Product Change Notification

Change Notification #: 109822 - 00
Change Title: Intel® Server System SR1680MV, PCN 109822-00, Product Design, System IO board design change
Date of Publication: April 08, 2010

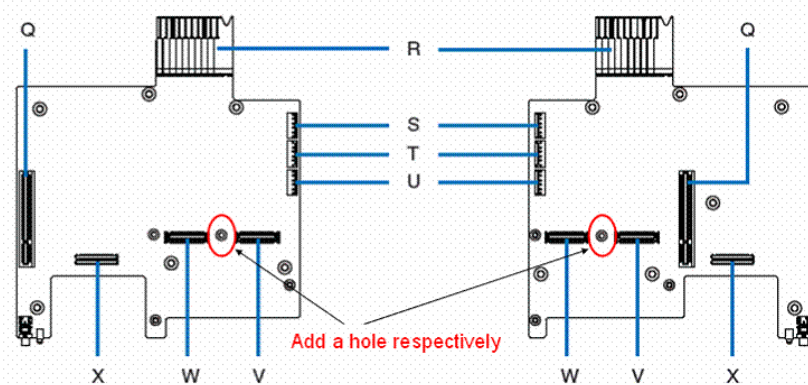
A space hole is being added on the System IO board (Right & Left) to enhance the retention mechanism and prevent potential shock & vibration risk during shipping with the new Intel® QDR InfiniBand expansion module.
